ADDENDUM

Project: Nampa ID Ridgevue Stake Suite Addition

Addendum No.: 1

Date: November 30, 2021

VINYL WALL MECHANICAL ENCLOSURE

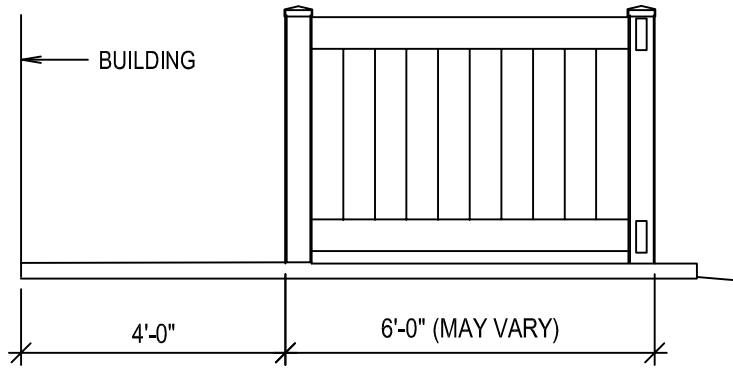
1. Add Note 10 to read as follows. New Mechanical Enclosure with Vinyl Fencing. See Detail 3/AS101 (This Addendum Sheets ADD1-1A & ADD1-1B) and Civil for more information. Color to match existing. "Note 10 to be added to north side of building where this is shown."
